MULTIPLE SEWERSHED PACKAGE 10B – OPEN CUT
Solicitation Number: CO-00285-SM
Job No.: 18-4542

ADDENDUM 1
08/23/19

No.	Revision	Drawn	Approved	Date
REVISIONS				
MULTIPLE SEWERSHED PACKAGE 10B-OPEN CUT				
DEVINE SANITARY IMPROVEMENTS STA 1+00 TO STA 5+00				
DEVELOPER:				
CONT.		BUDGET PROJ.		
SUBMITTED				
APPROVED				
MAP No. 164572		SHEET 8		
SECT. No.		DR. CK. JOB No. 18-4542 OF 28

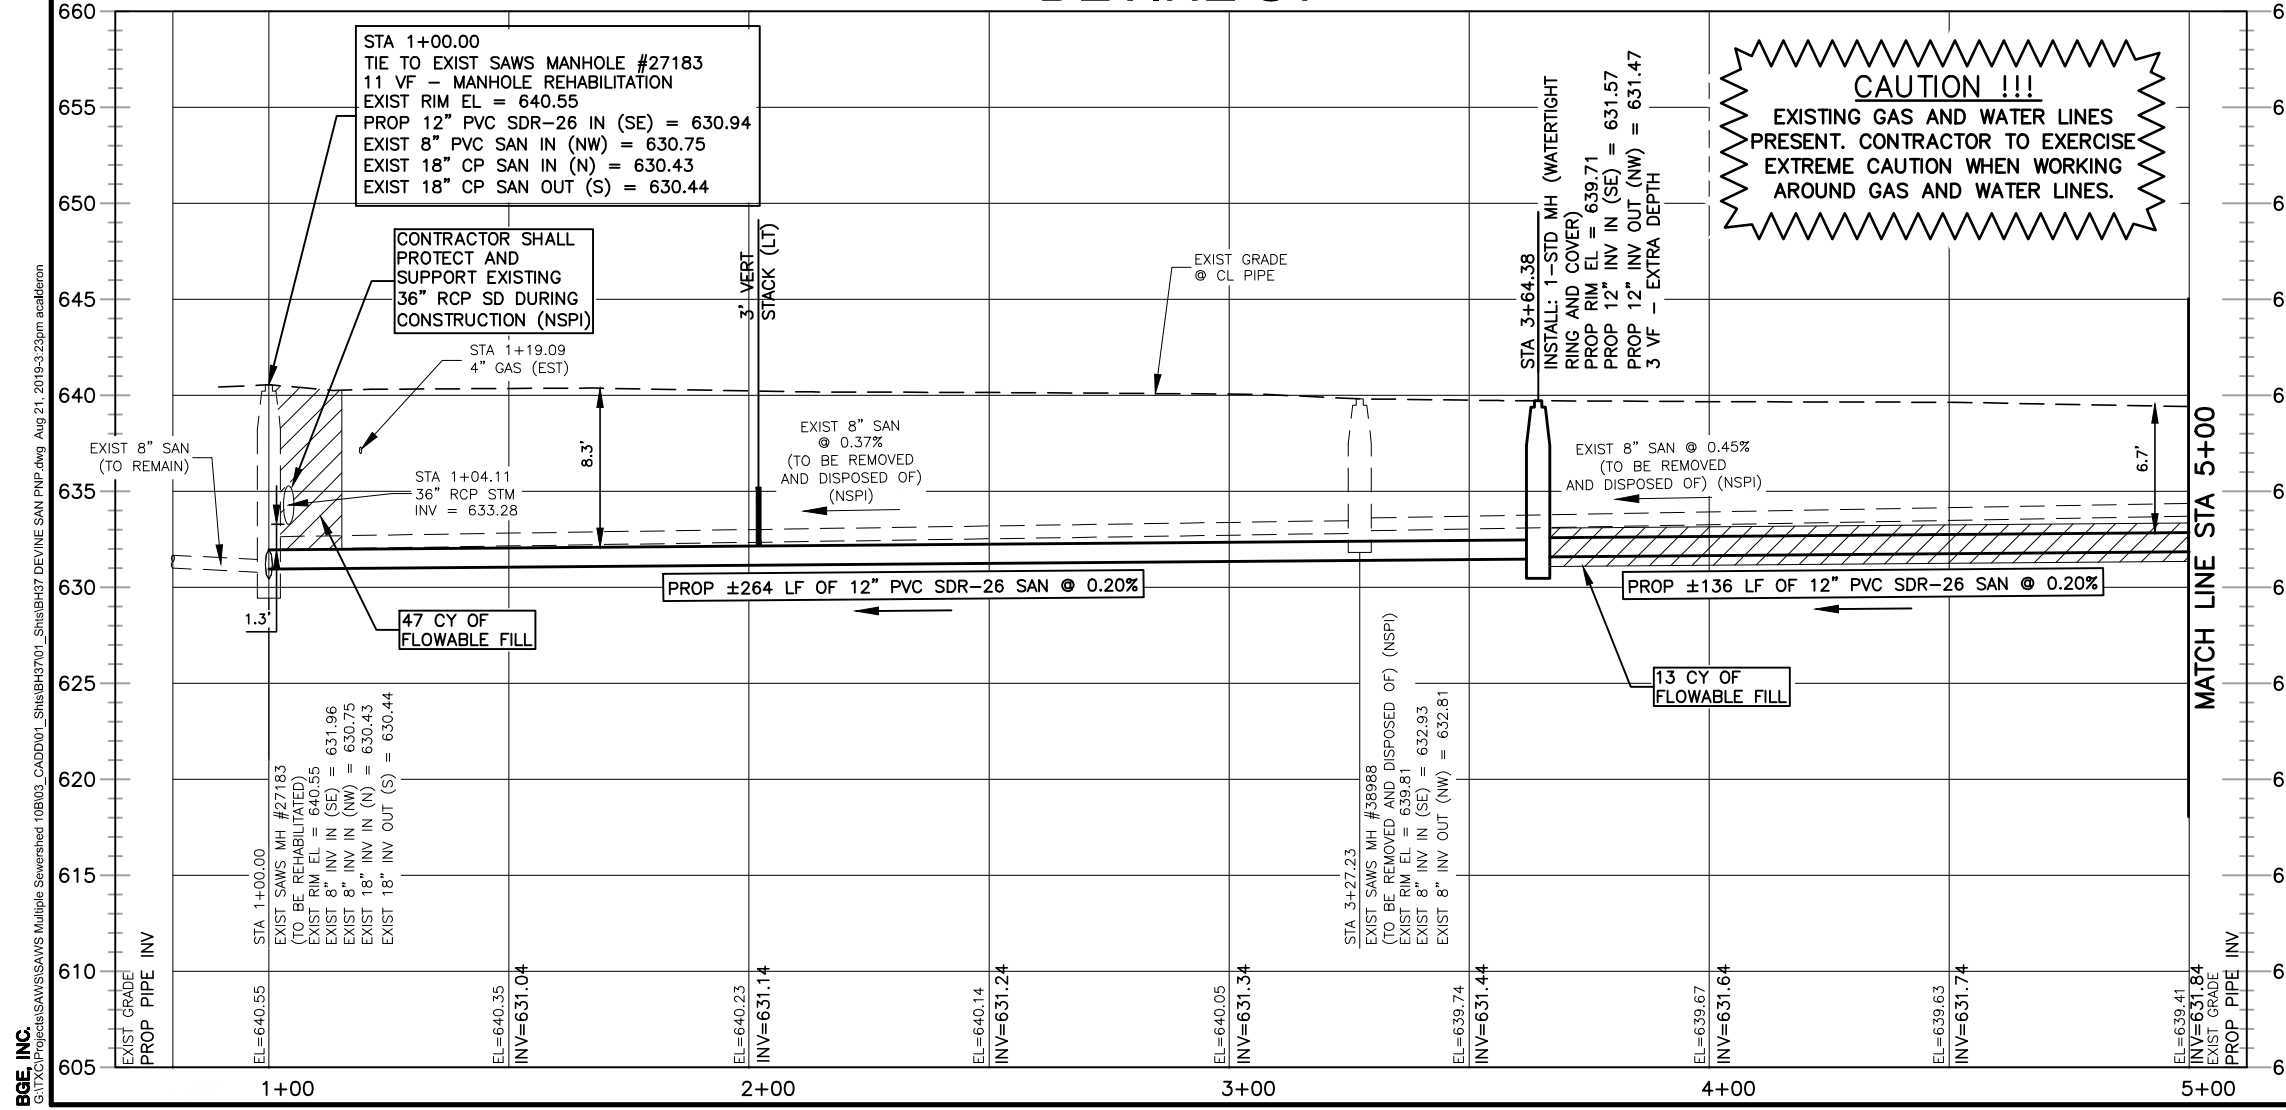
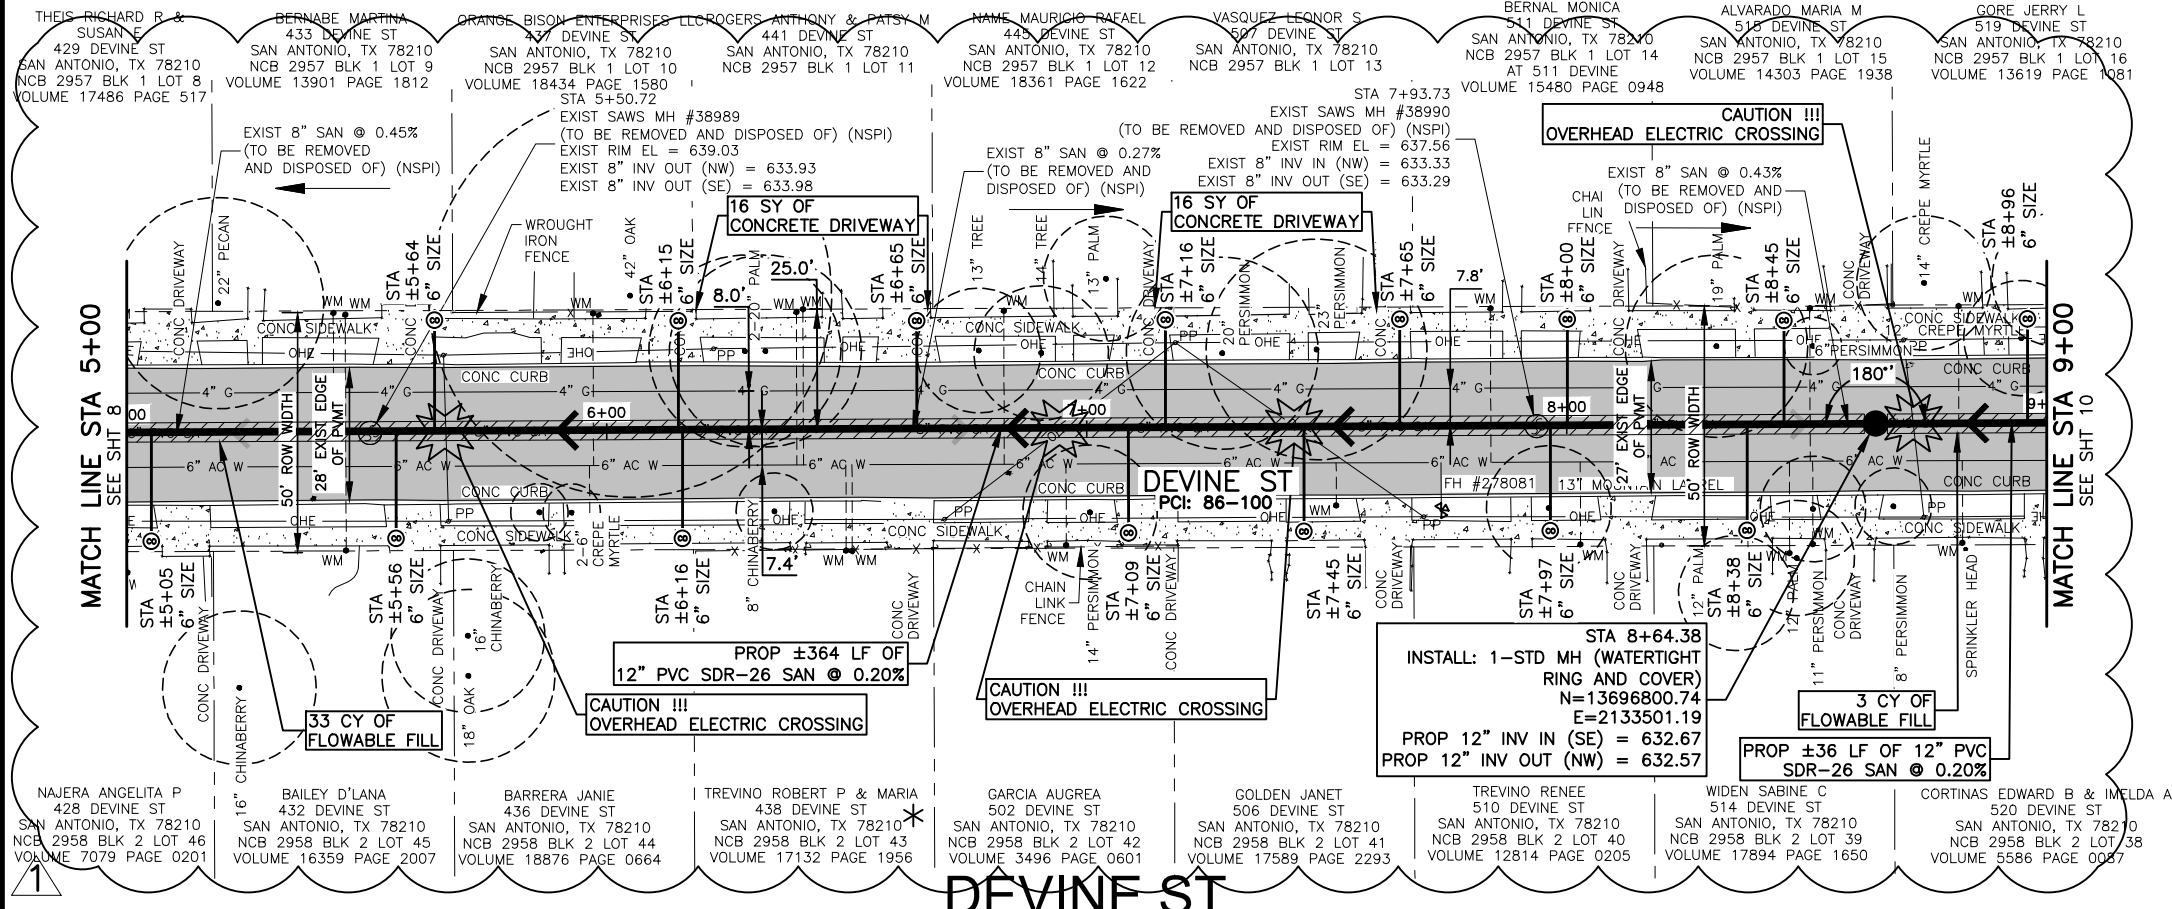
6. DELETE **Sheet 8 of 28** of the SEWER PLANS in its entirety and REPLACE with the attached **Sheet 8 of 28**, dated 8/21/19. Sheet 8 has been revised to show updated tree species and/or location.

SHEET 9 OF 28

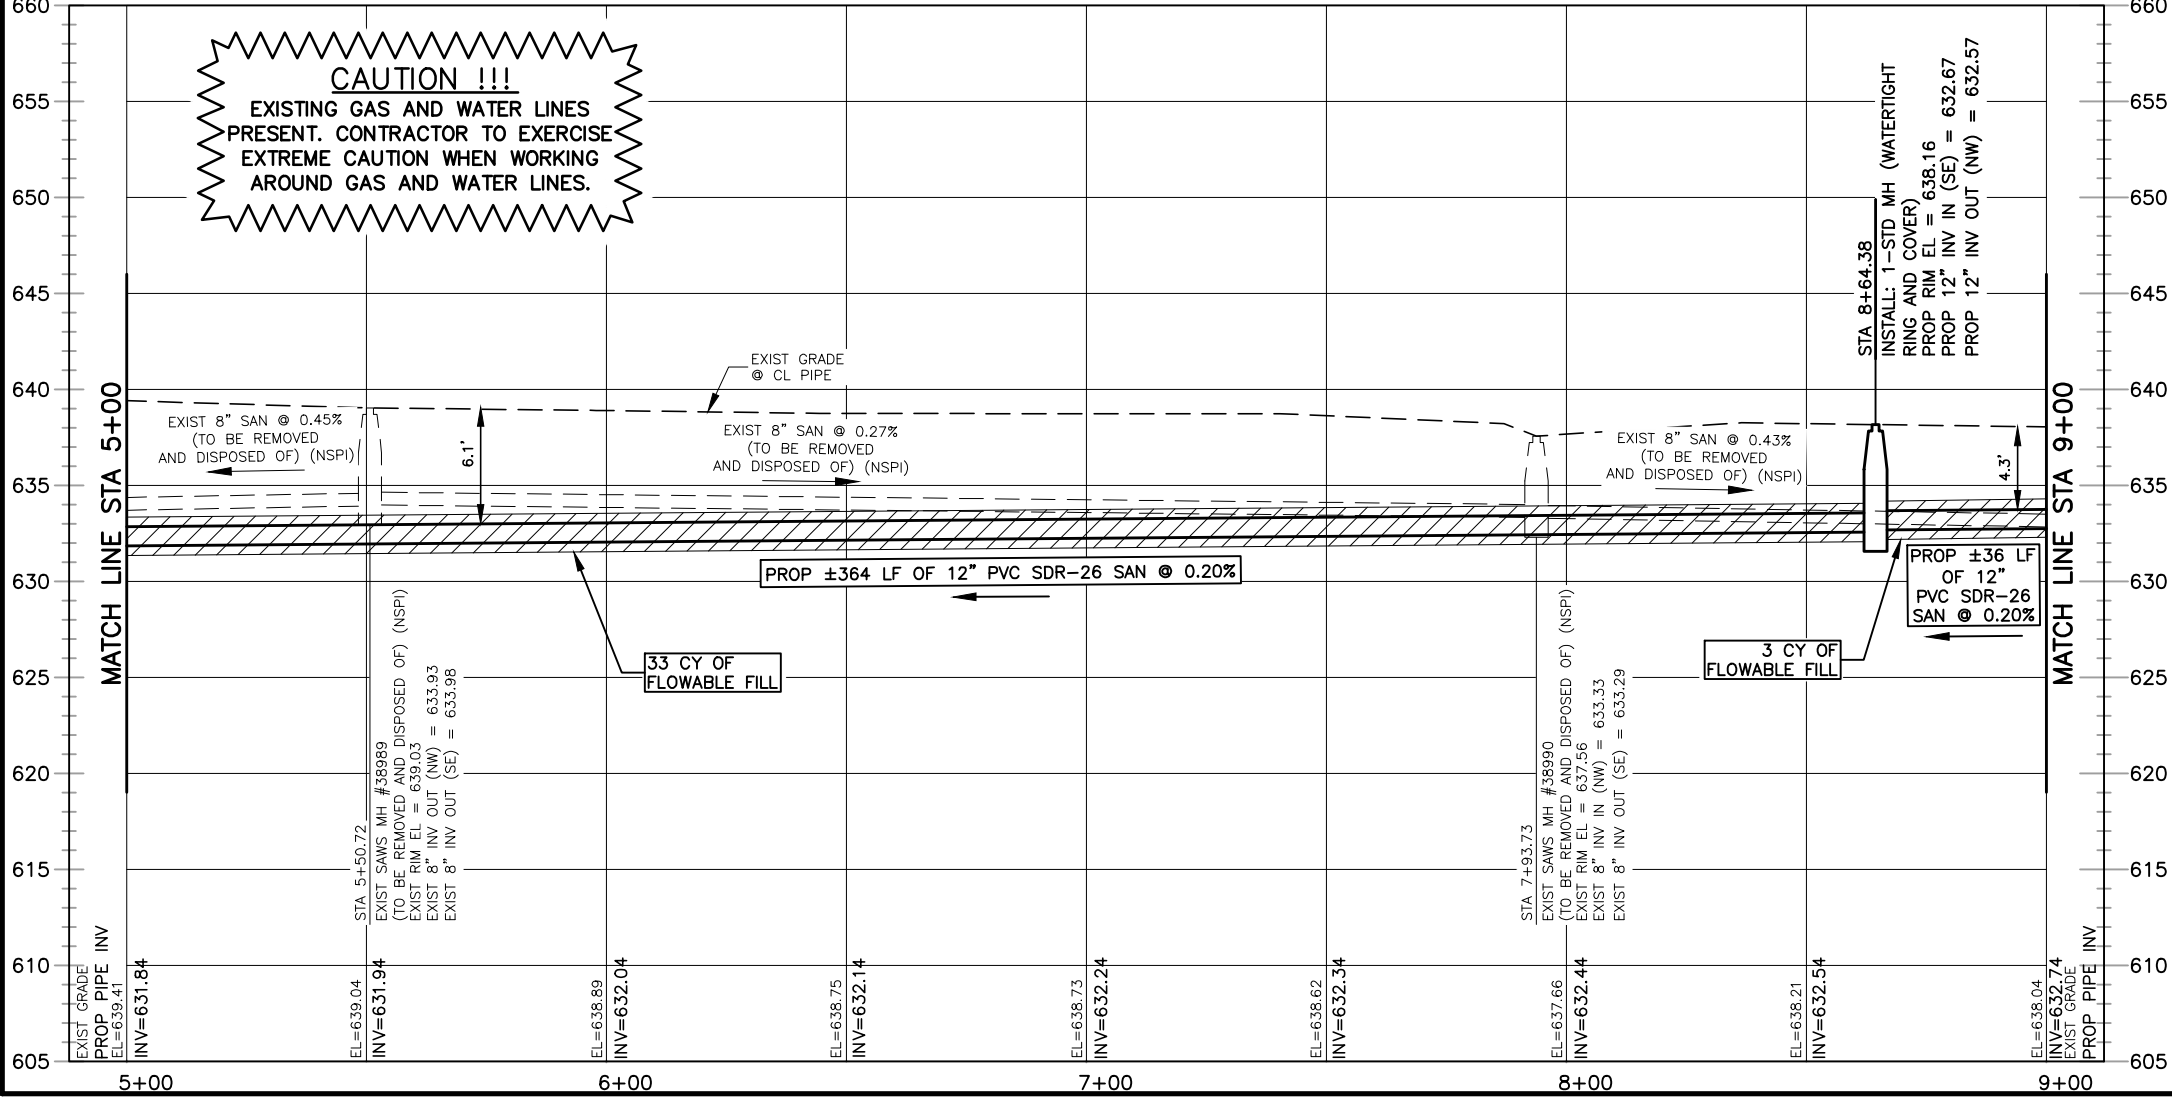
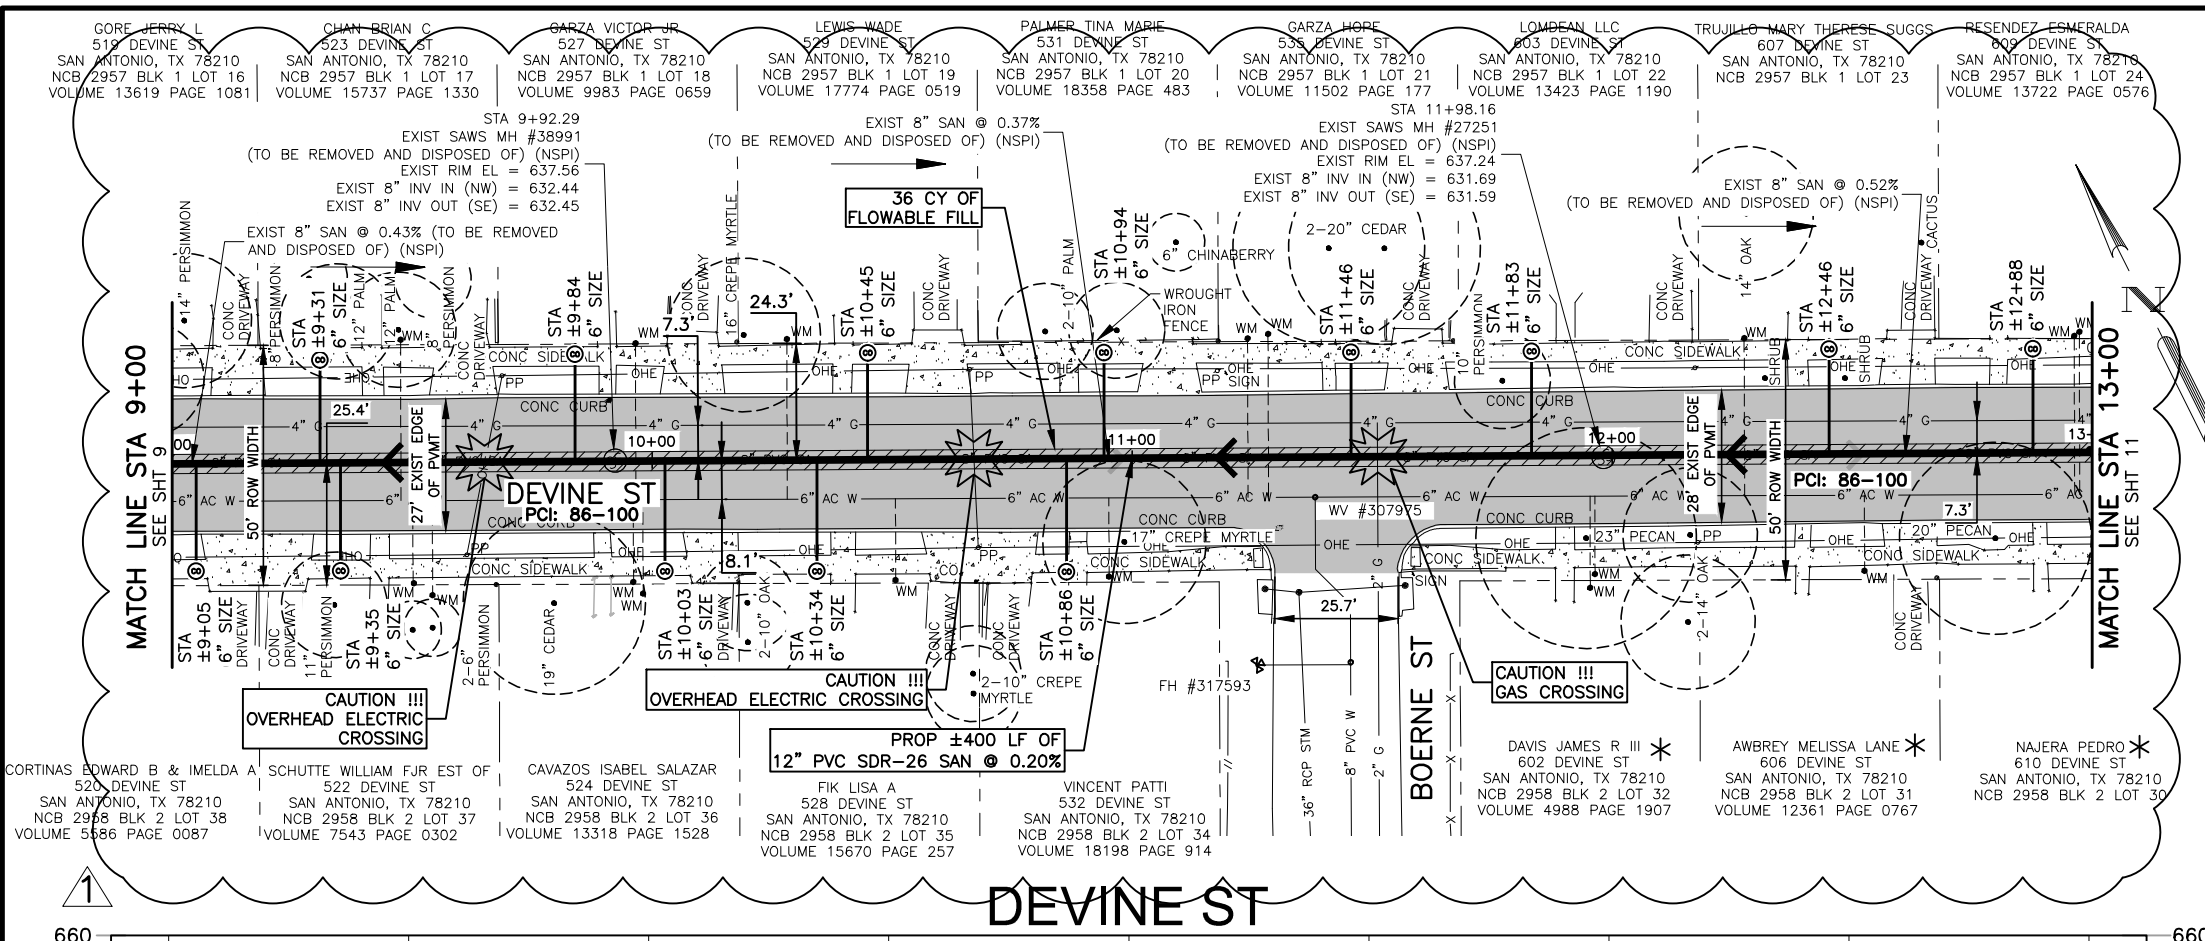
7. DELETE **Sheet 9 of 28** of the SEWER PLANS in its entirety and REPLACE with the attached **Sheet 9 of 28**, dated 8/21/19. Sheet 9 has been revised to show updated tree species and/or location.
